**ONE MONUMENT SQUARE
 ENTRANCE AND LOBBY RENOVATIONS
 FINARD & COMPANY
 PORTLAND, MAINE**

TITLE
SITE LAYOUT
PLAN

C1

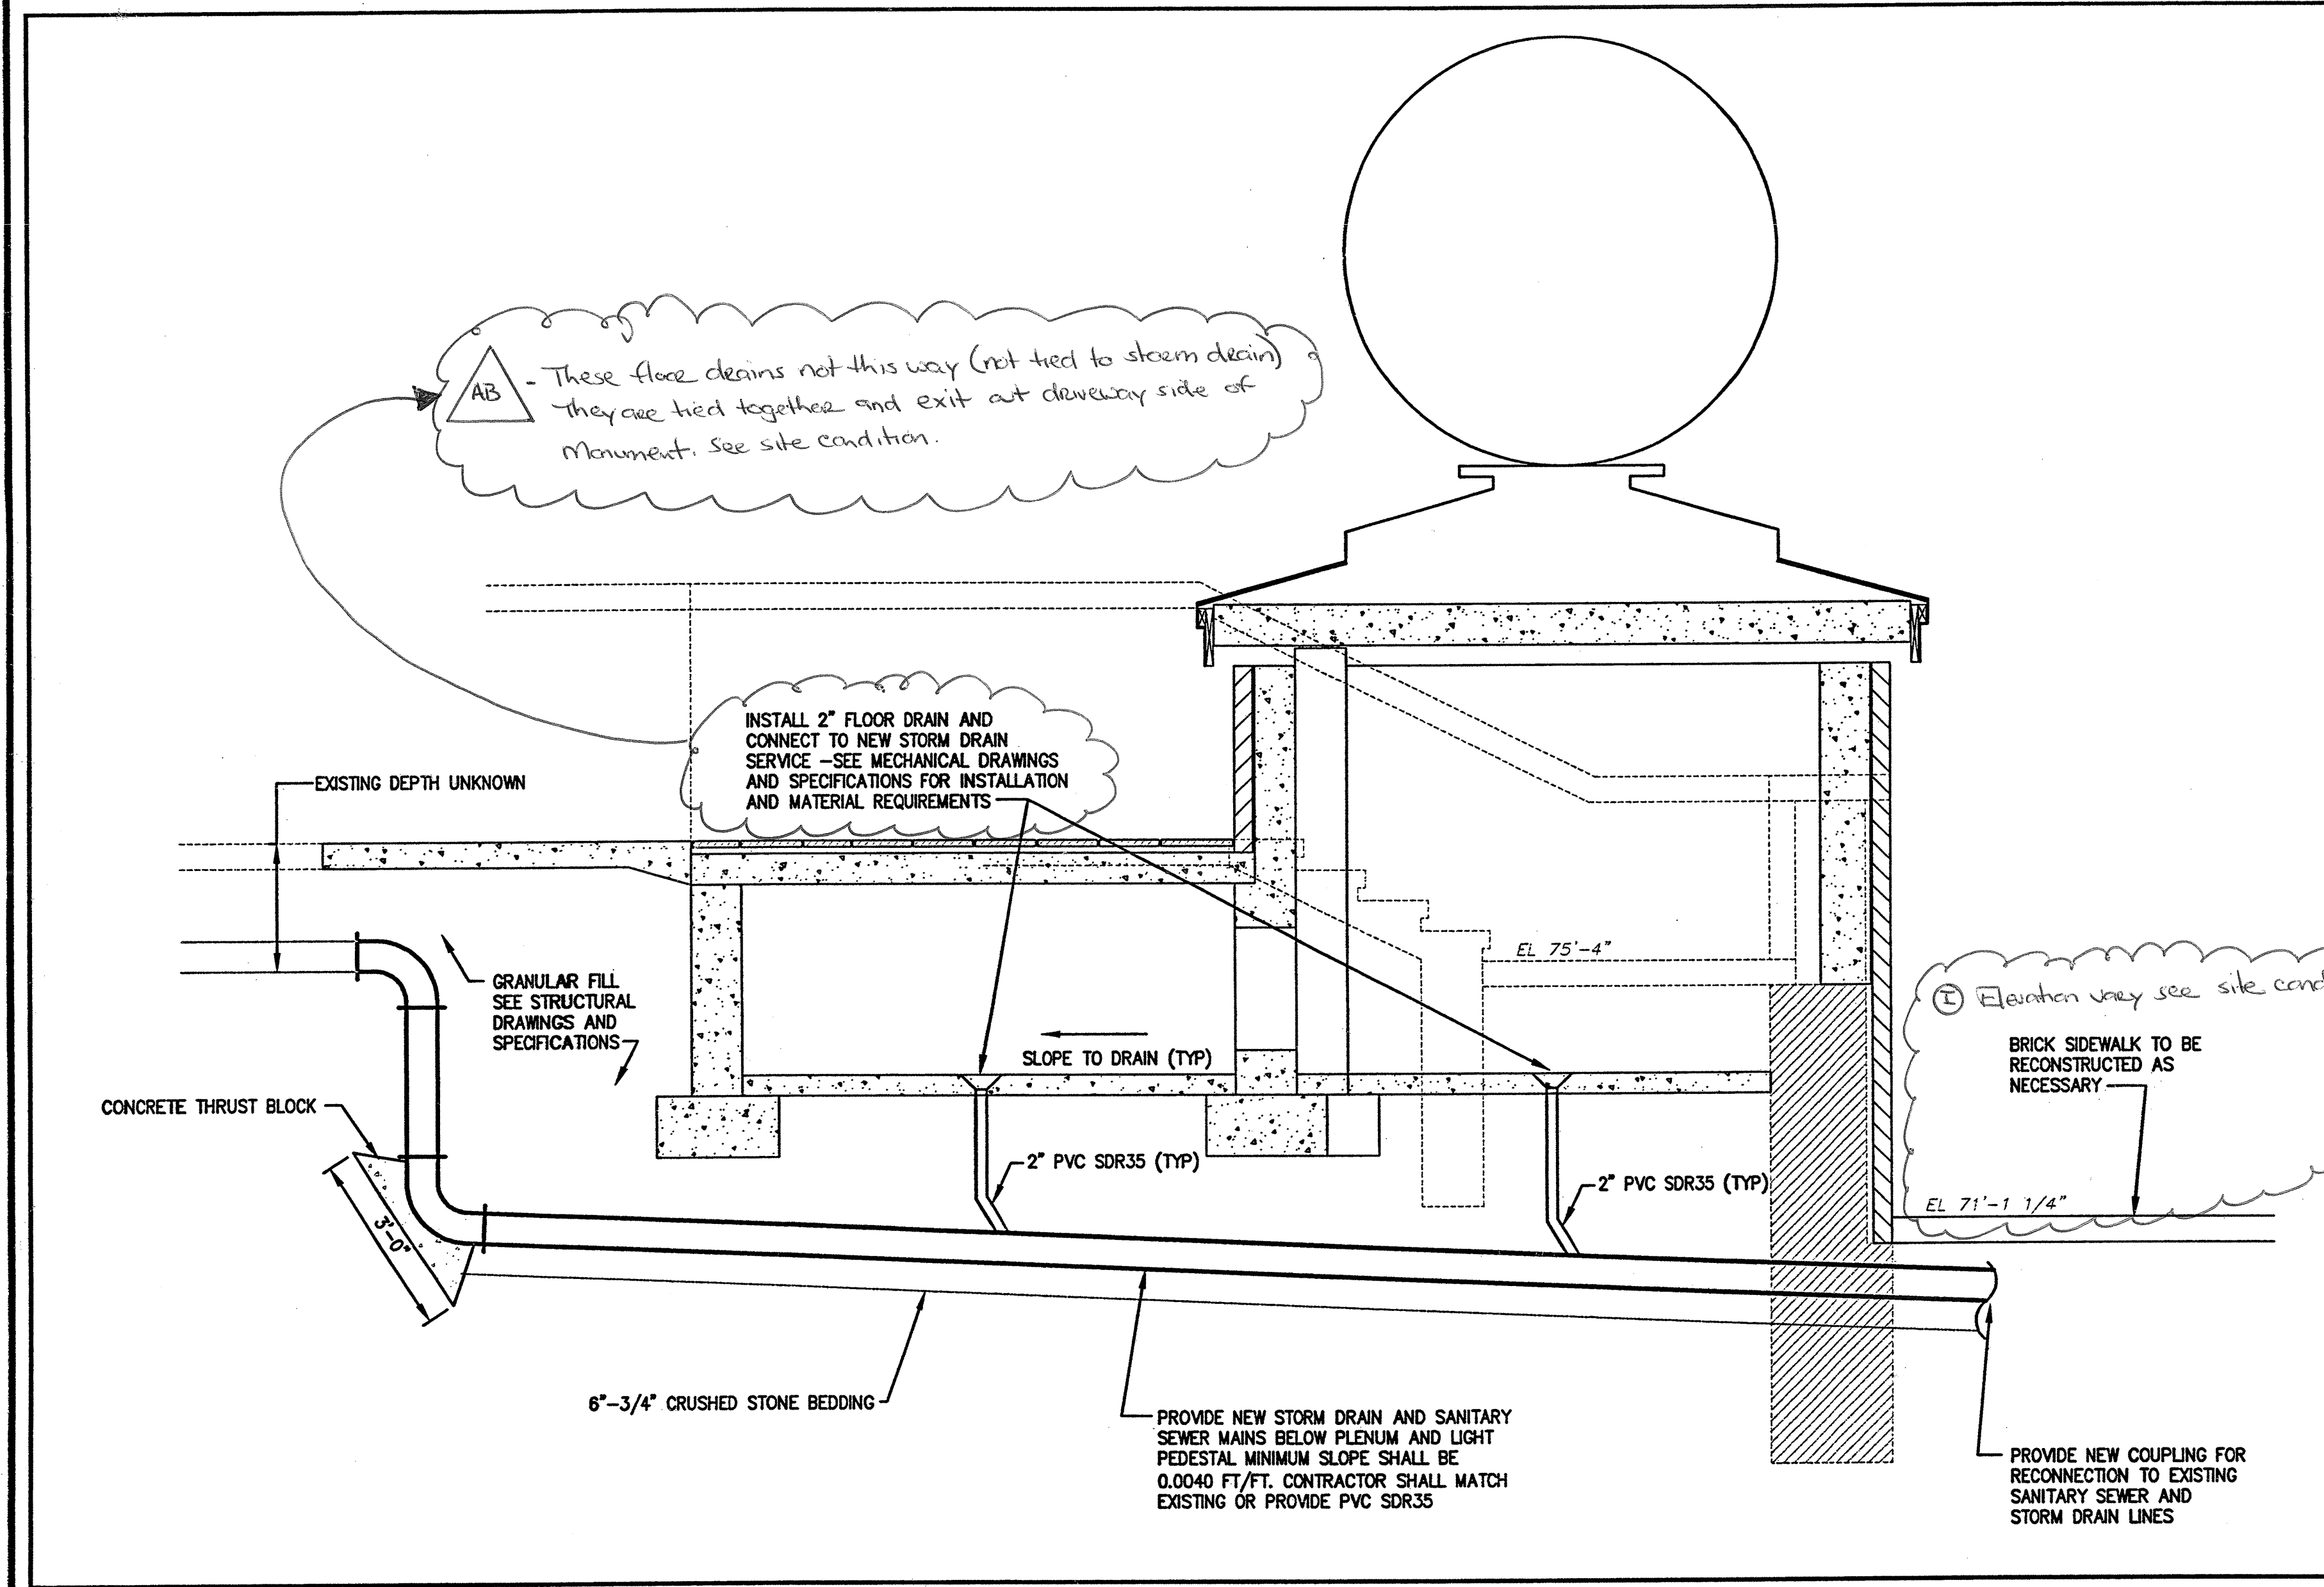
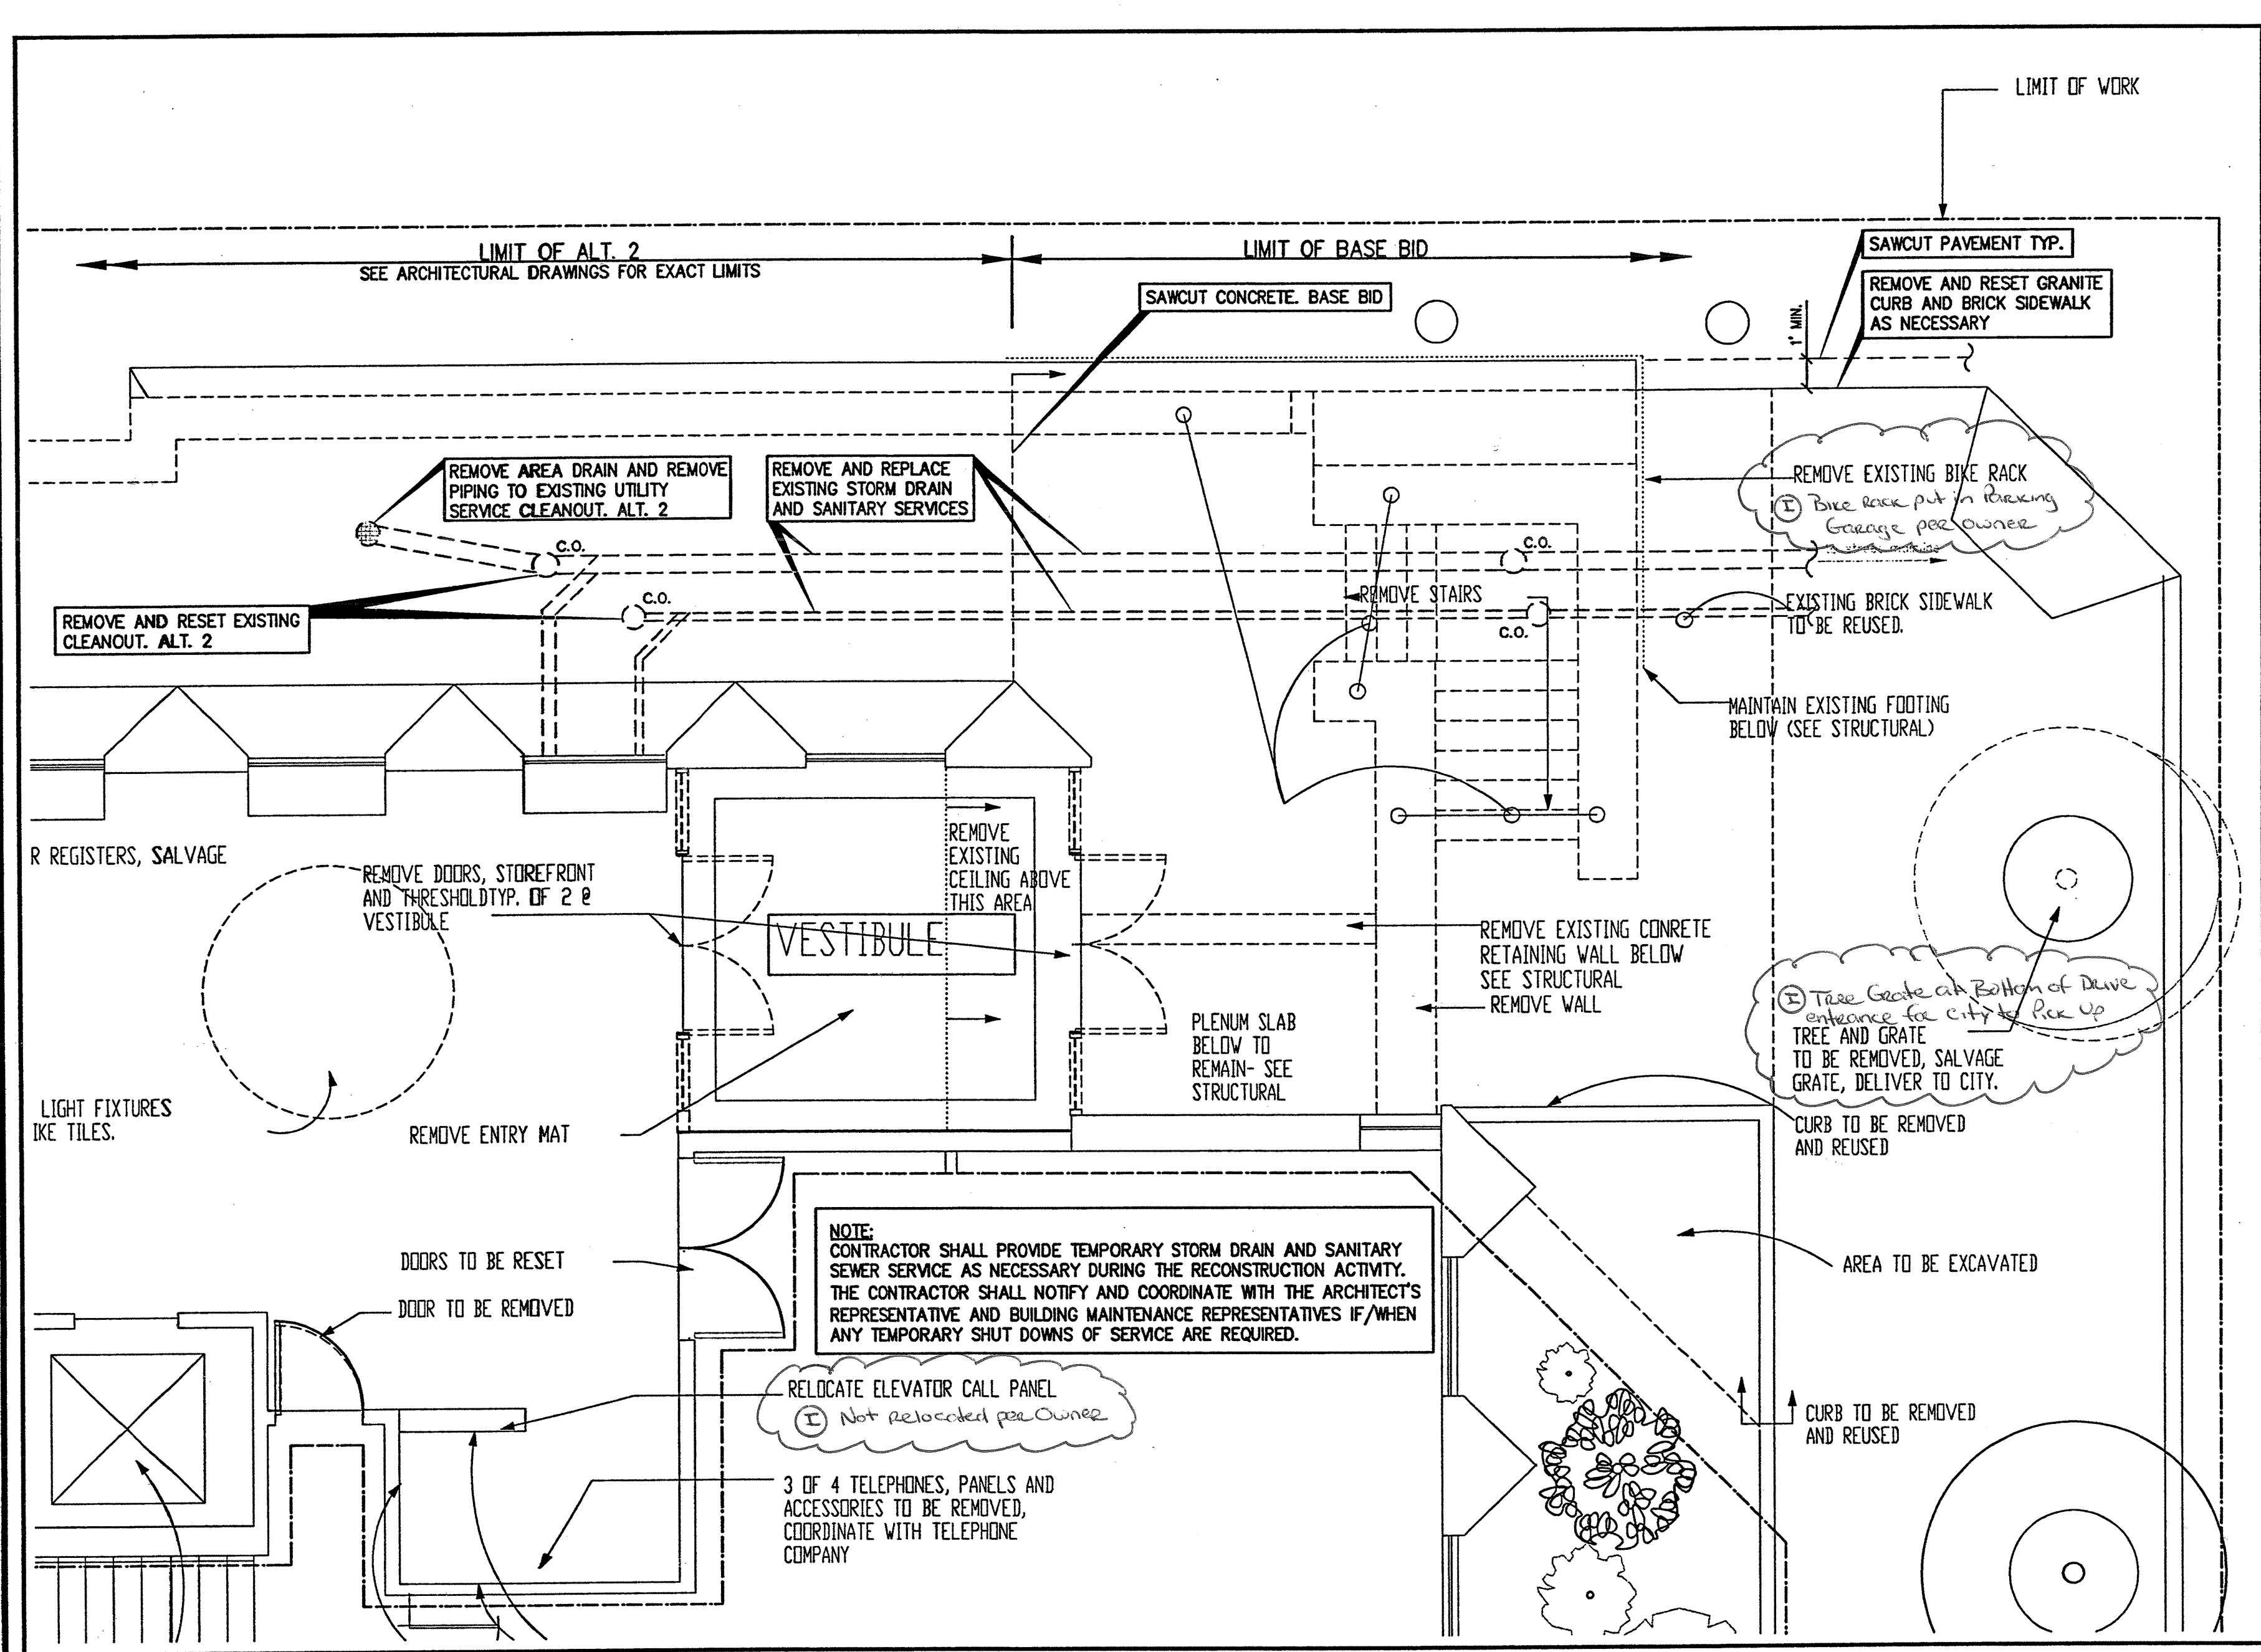
Ⓢ Teach drain line this not as Plan view A-1
 Ⓢ [Low Point] Section of Poly drain correct drain location at A4#2 wall see site conditions
 Ⓢ Call Alford ax said he could do the work, but never seen them come to site

Ⓢ These floor drains not this way (not tied to storm drain) they are tied together and exit at driveway side of Monument. See site conditions.

Ⓢ Elenton way see site conditions
